APPLICATION PURSUANT TO SECTION 75W OF THE ENVIRONMENTAL PLANNING AND ASSESSMENT ACT 1979

SHOALHAVEN STARCHES

- TO THE SIZE AND LOCATION OF THE APPROVED PACKING PLANT;
- PROVISION OF AN ADDITIONAL RAIL SPUR LINE AND REALIGNMENT OF BOTH RAIL SPUR LINES AND ROAD ACCESS ON THE PACKING PLANT SITE; AND
- CHANGE TO THE ALIGNMENT AND LOCATION OF BOLONG ROAD BRIDGE CROSSING

RELATING TO PROJECT APPROVAL MP06_0228
SHOALHAVEN STARCHES EXPANSION PROJECT

Figure 4: Site plan depicting areas associated with this Modification Application.

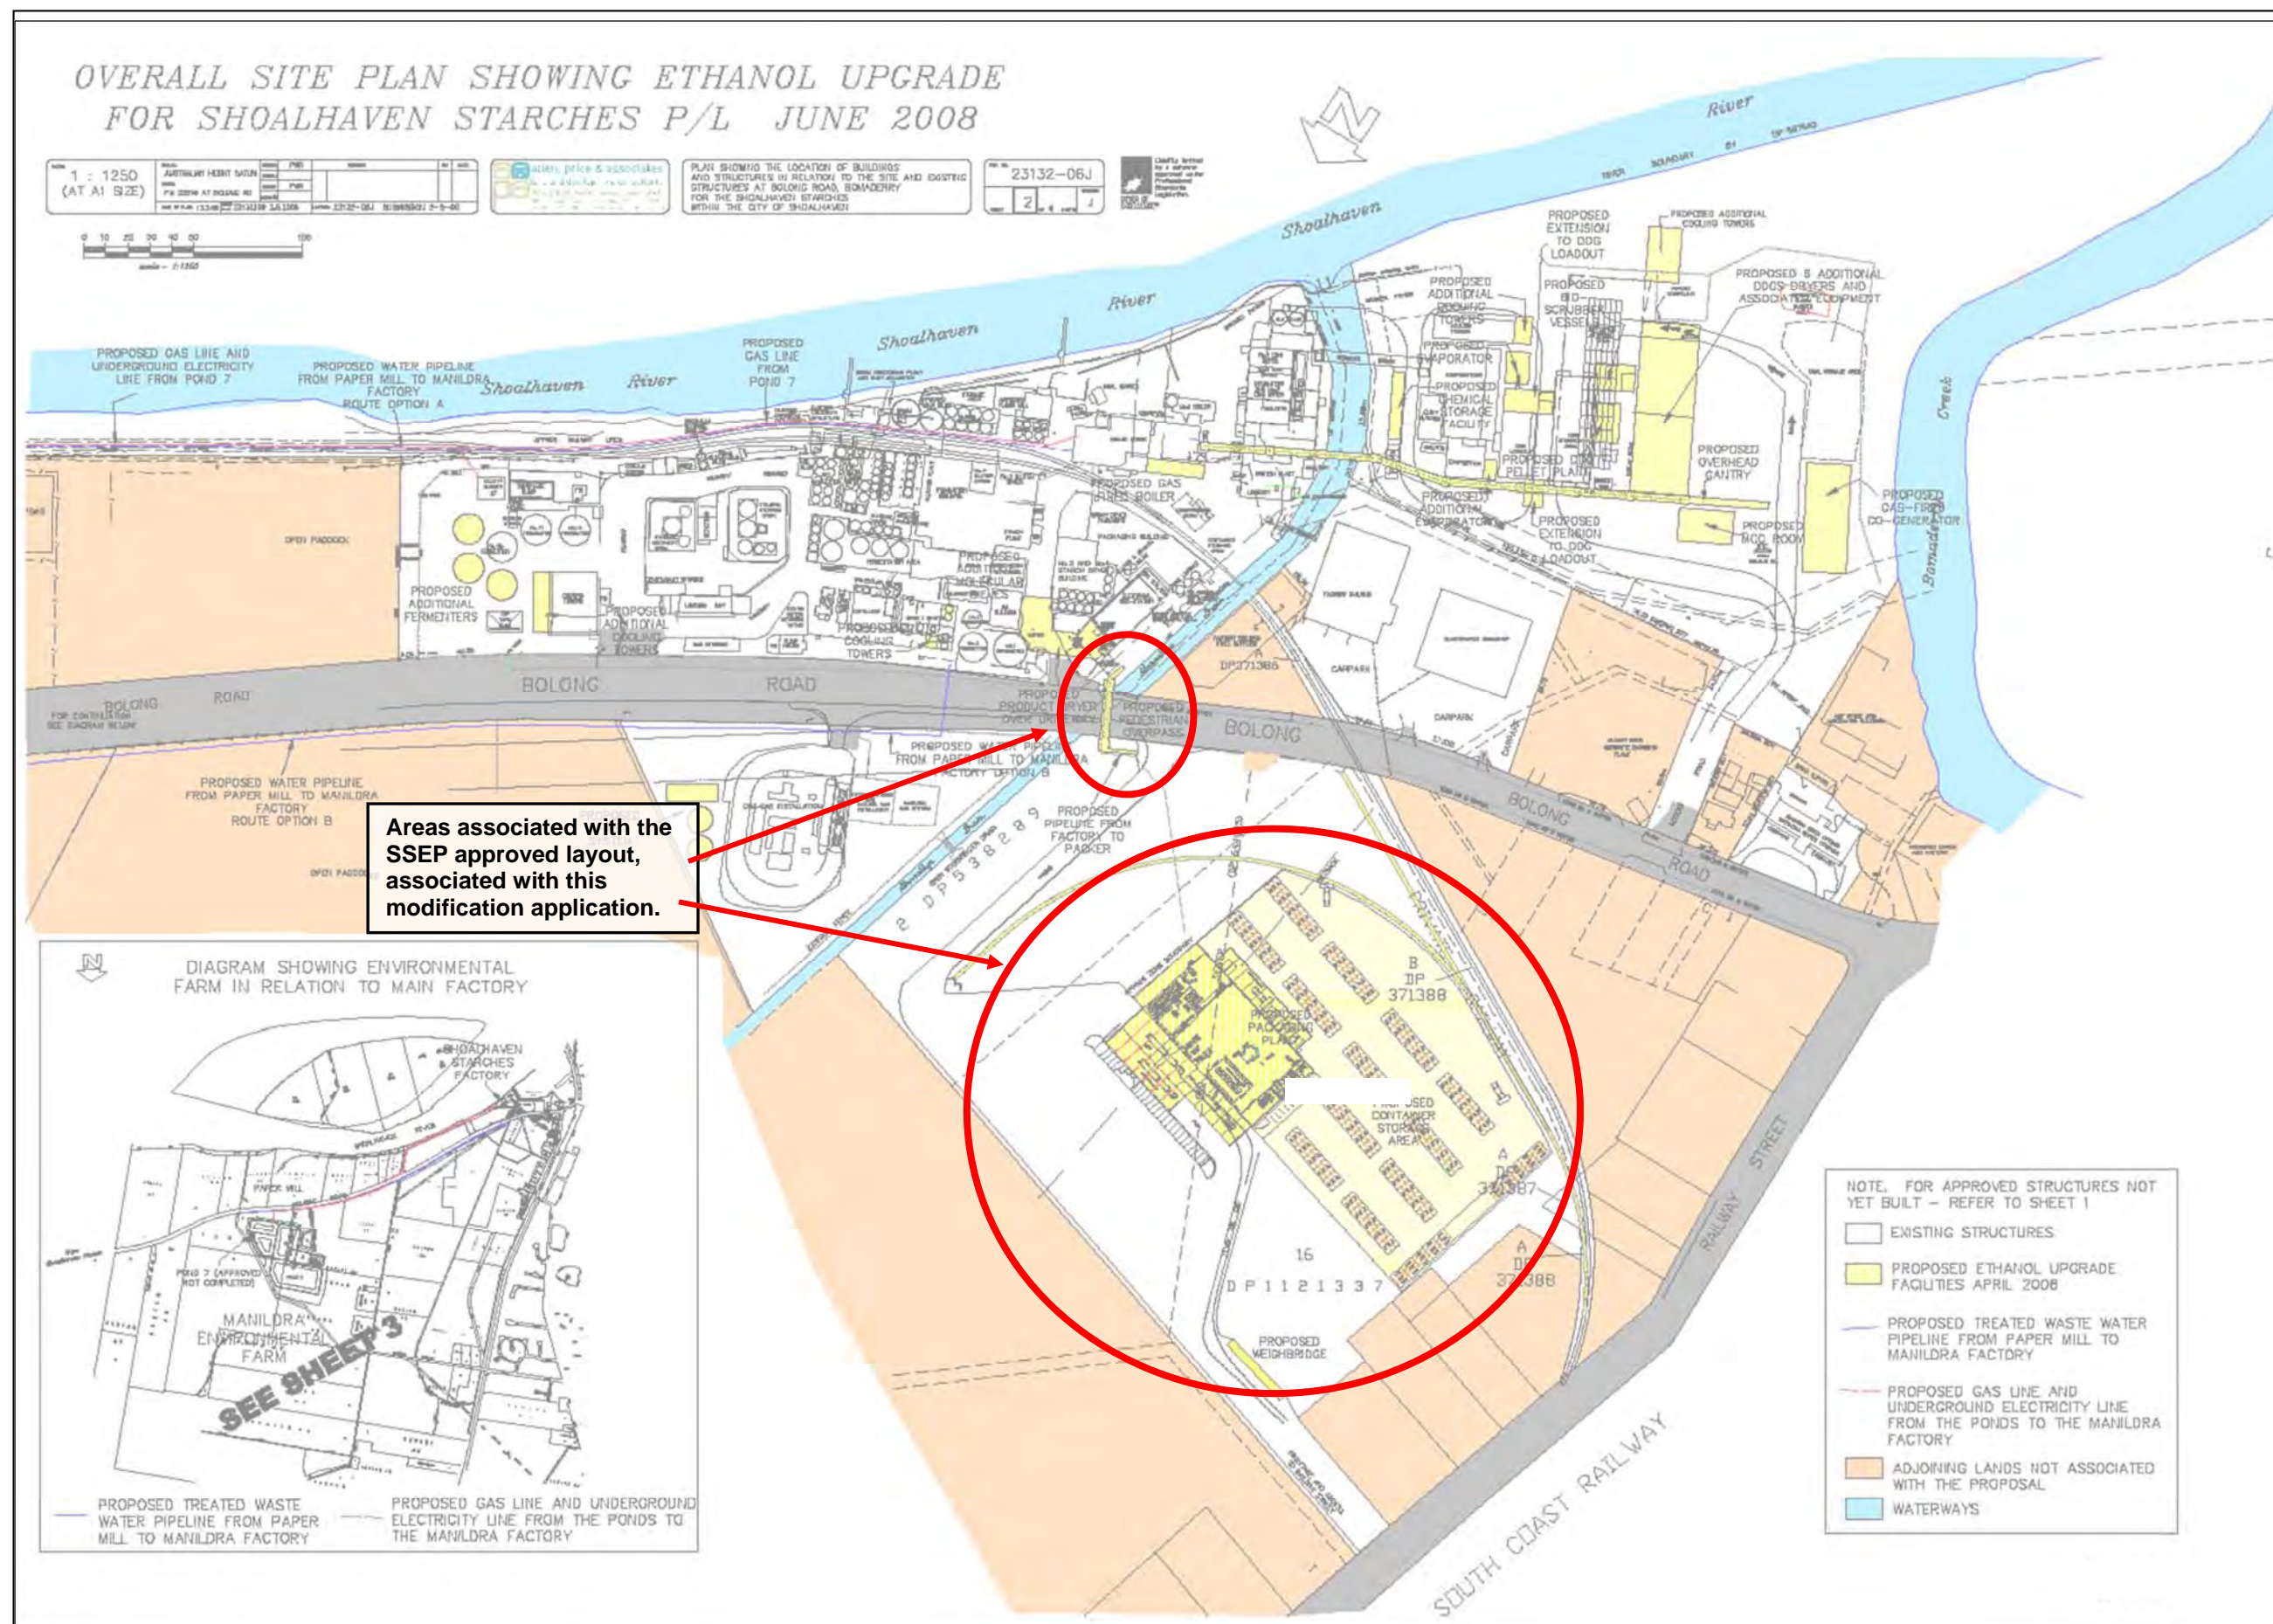
Figure 4 is a plan of the existing factory site depicting the layout of existing plant on the site as well as plant that has been previously approved as part of the Shoalhaven Starches Expansion Project (MP06_0228).

Figure 6: Excerpt of Plans showing Modification to approved Packing Plant (Manildra Group)

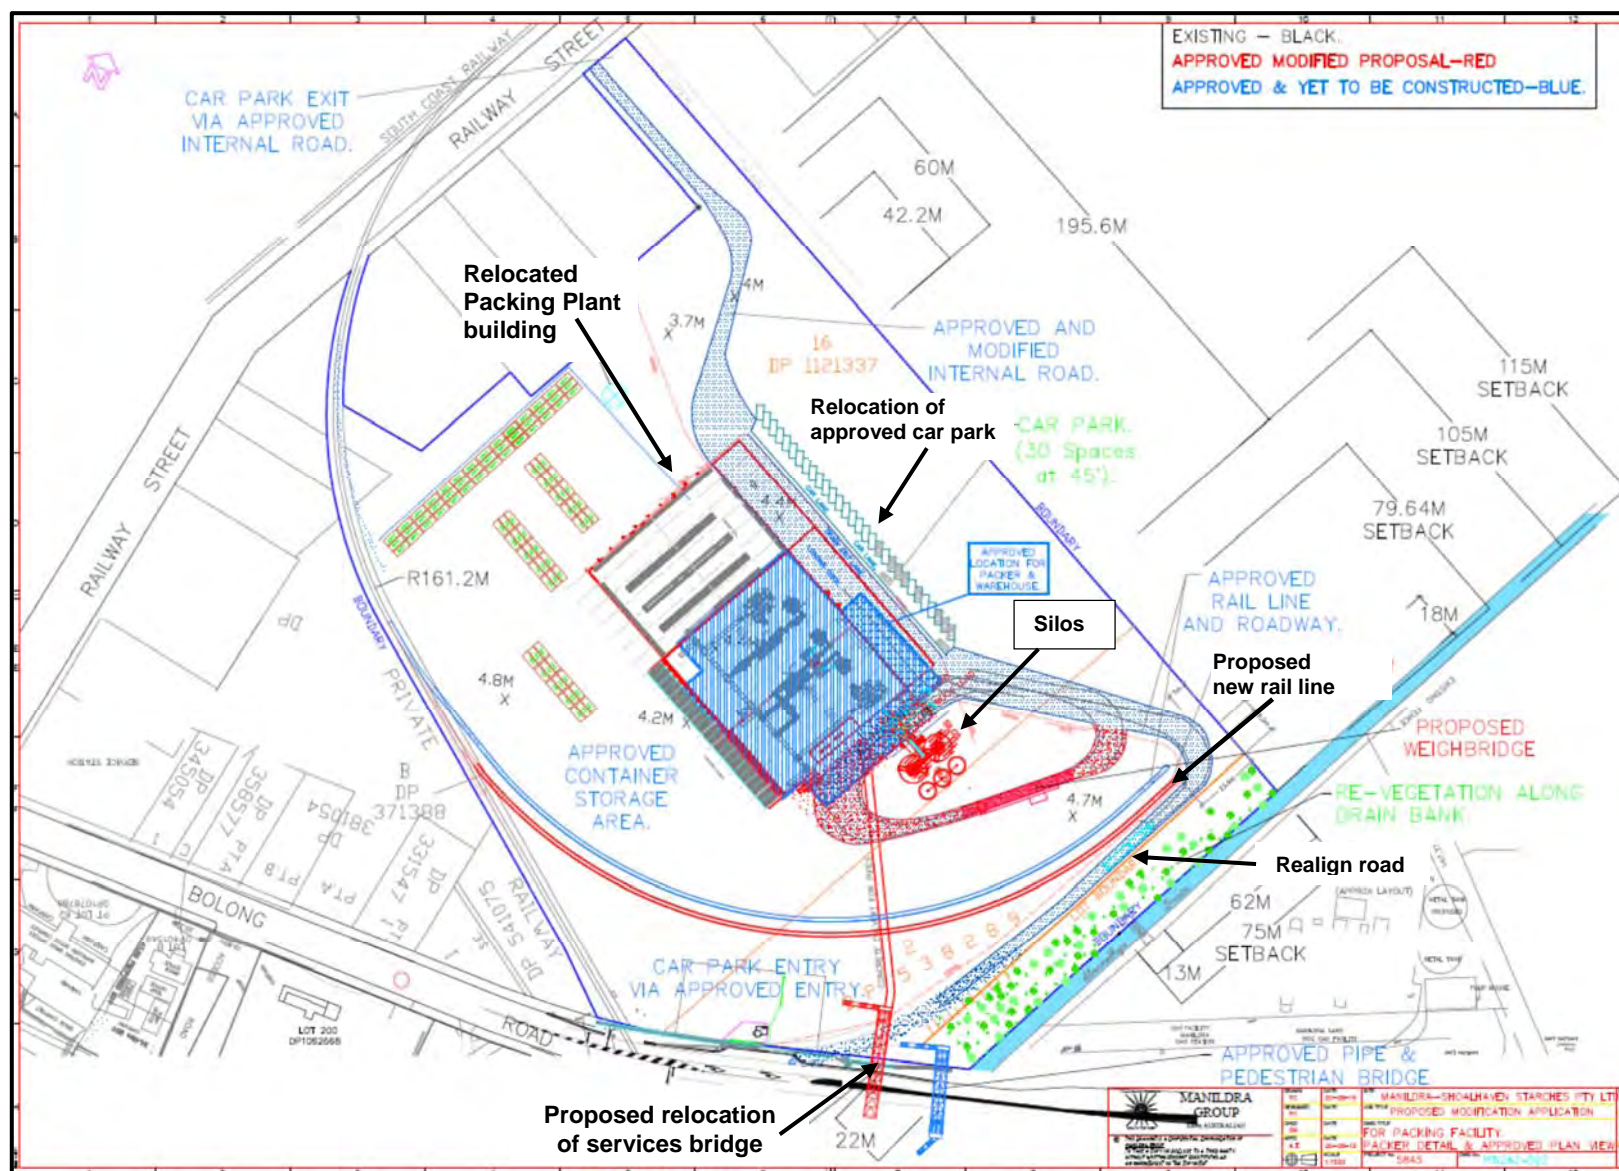
Figure 6 shows the approved Packing Plant and the proposed structures under the modification application. Detailed plans of the modification are included as **Annexure 4** to this EA.

Under the original SSEP it was proposed to provide a single rail spur line to service the new packing plant. The increase in the number of finished product containers that will now be required to serve the site by rail will necessitate the provision of a second rail spur line in addition to the original approved rail line.

If a single rail spur line was retained with the increased containers, this would result in a doubling of rail crossings of Railway Street, further disrupting traffic travelling along this industrial road. A second spur line will enable trains to be spilt and parked on the subject site reducing the potential for rail crossings and subsequent disruptions to traffic flow along Railway Street.

Figure 35: Photomontage of proposed Modified Packing Plant as seen from Bolong Road.

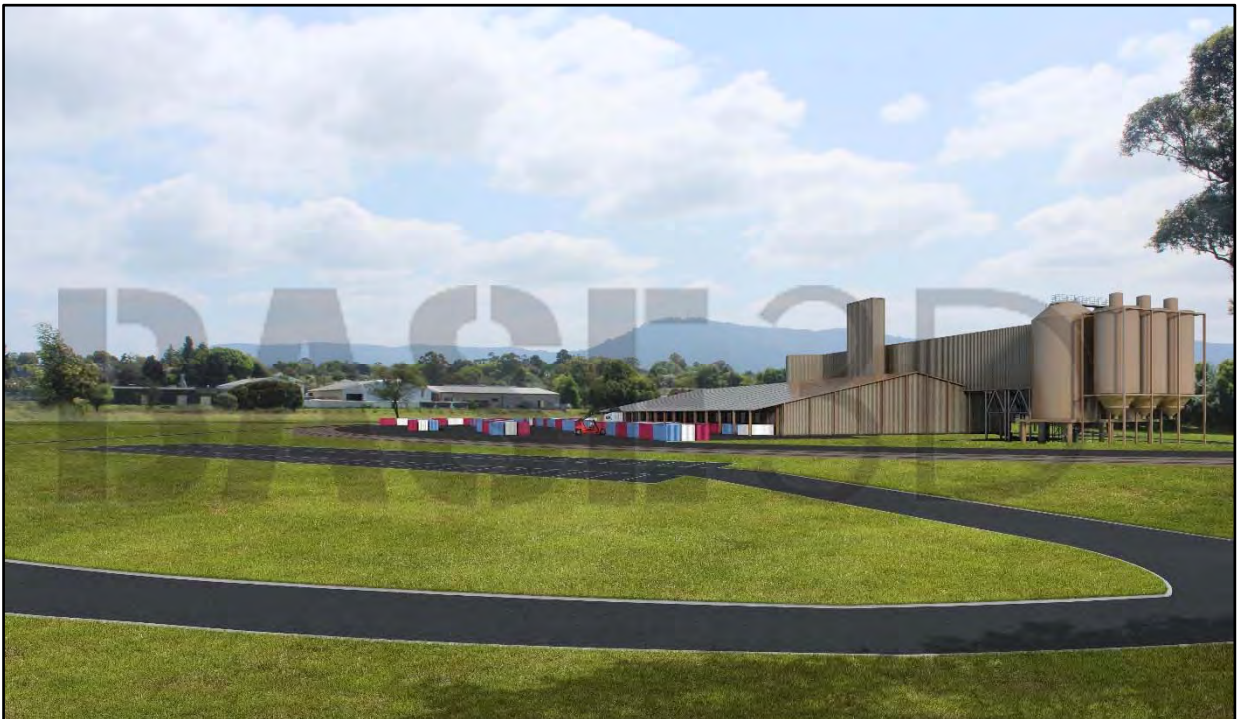
Bolong Road will be the main vantage point from where the modified packing plant will be visible. In accordance with the Department requirements for the preparation of this EA, photomontages have been prepared showing the visual impact of the approved packing plant and modified packing plant when viewed from vantage points along Bolong Road (**Figures 34 to 37**).

As is evident from the photomontages in **Figures 34 to 37** the proposed modified packing plant will be set further back from Bolong Road which will assist in reducing its scale and visual impact when viewed from along Bolong Road.
